FIELD SERVICE BULLETIN

FSB Number:	LVCCFSB2005-312
Authors:	Darwin Garcia
Date:	October 28, 2005
Total No. of Pages:	3
Subject:	V3 Torn P-Flex
Model Affected:	V3
Level of Repair:	2

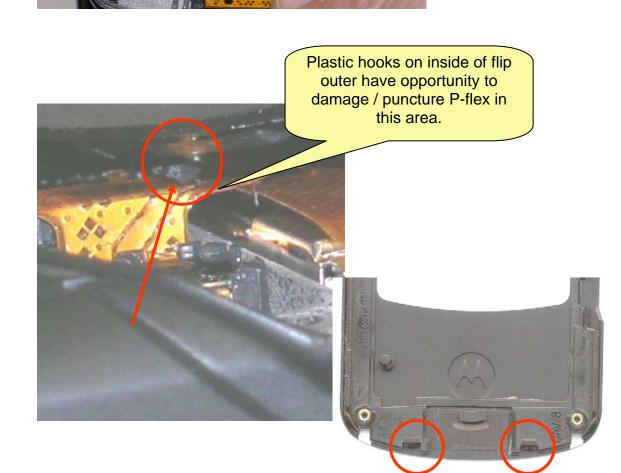
The root cause was determined to be a torn P-Flex near the earpiece speaker. In this unsupported area there is an opportunity for operator to touch this area when pushing down on earpiece speaker / RTC battery or when positioning the flip outer housing plastic hooks to torn the flex during the assembly process.

Operator finger tip opportunity to damage / puncture P-flex in this area.

The factories change the SOP to reflect handling damage opportunity this P-flex area. The SOP highlights not to push on unsupported area of P-flex in this area:

* With finger tip during Earpiece & RTC handling, and when pushing down to adhere adhesive backing.

* During placement of flip outer housing, use caution not to touch flex in this area (with bottom side plastic hooks).

When servicing any V3 customer phones with described issue, the P-Flex must be replaced. Added care must be taken on this area of the P-Flex during the replacement. Personality Flex Assy # 8490007N01
